SOLICITATION AMENDMENT MODIFICATION DE L'INVITATION

Title - Sujet CCGS Samuel Risley refit 2014	
Solicitation No. - N° de l'invitation F2599-145028/A	Amendment No. - N° modif. 007
Client Reference No. - N° de référence du client F2599-145028	Date 2014-06-09
GETS Reference No. - N° de référence de SEAG PW-\$\$MD-018-24496	
File No. - N° de dossier 018md.F2599-145028	CCC No./N° CCC - FMS No./N° VME
Solicitation Closes - L'invitation prend fin at - à 02:00 PM on - le 2014-07-03	Time Zone Fuseau horaire Eastern Daylight Saving Time EDT
F.O.B. - F.A.B. Plant-Usine: <input type="checkbox"/> Destination: <input type="checkbox"/> Other-Autre: <input type="checkbox"/>	
Address Enquiries to: - Adresser toutes questions à: Vandal, Paul	Buyer Id - Id de l'acheteur 018md
Telephone No. - N° de téléphone (819) 956-0645 ()	FAX No. - N° de FAX (819) 956-0897
Destination - of Goods, Services, and Construction: Destination - des biens, services et construction:

QUESTIONS & ANSWERS

GREY WATER LAYOUT DIAGRAM

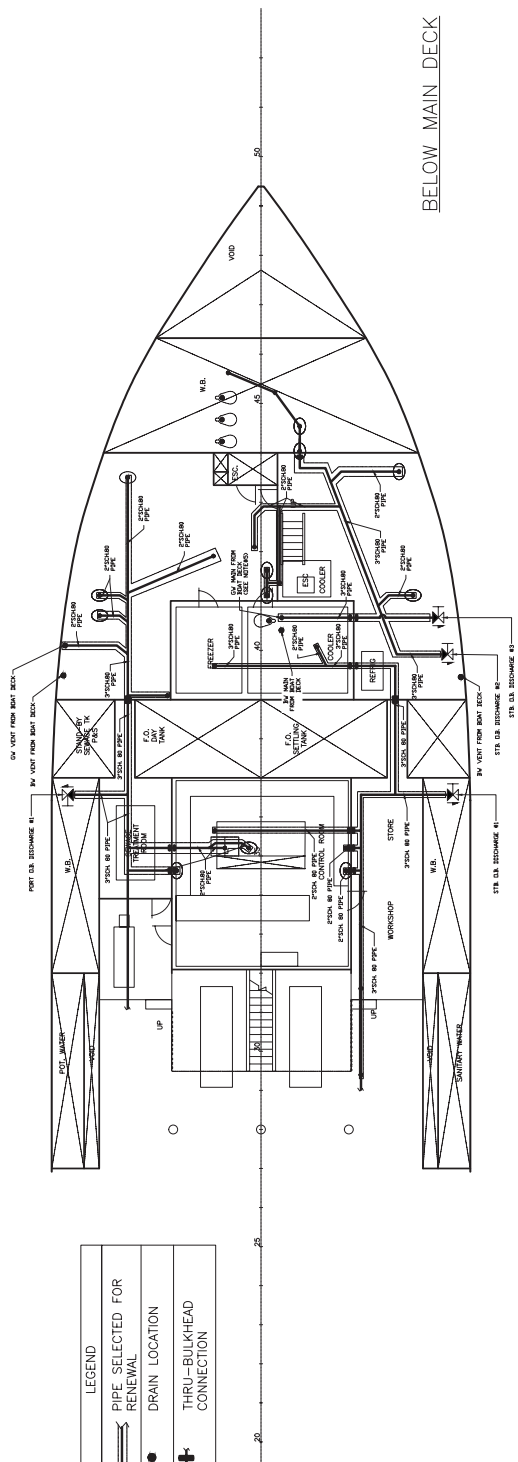
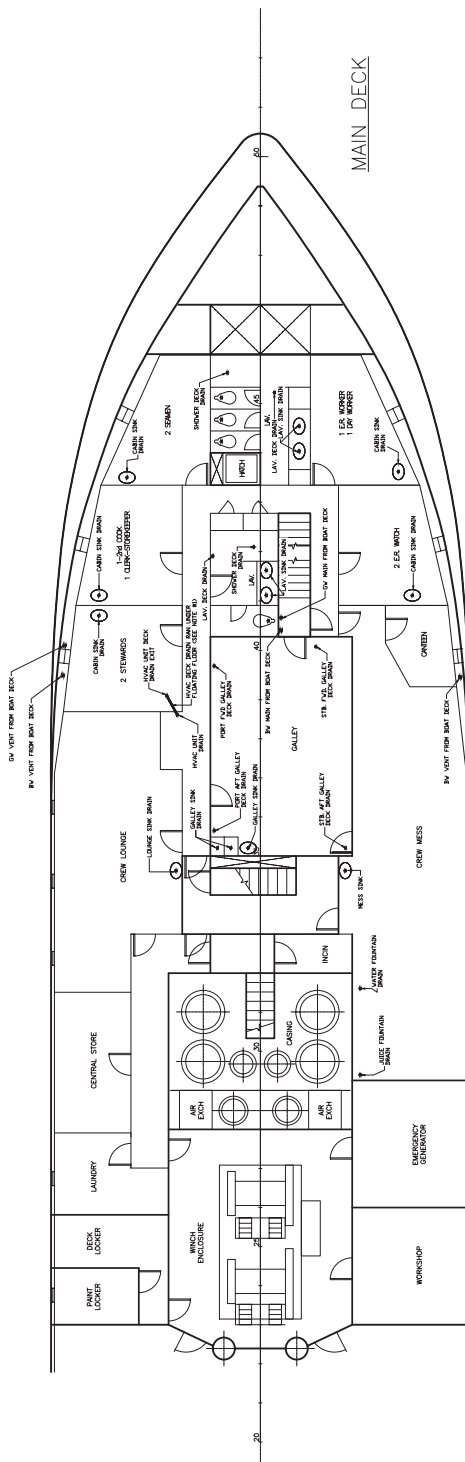
On specification item number 8 Main Deck Grey Water Drains and Black Water Pipe Replacement I have a question regarding the size of piping to be used.

What is the piping dimensions for these two systems?

CCG has revised the drawing No. CMS30-236-PL sheets 1 / 2 and 2 / 2 (Rev 1) (updated pipe dimensions), which shows the dimensions added.

1	UPDATE PIPE DIMENSIONS	CJ	2014-06
0	INITIAL	CJ	2014-02
rev	description	by	date
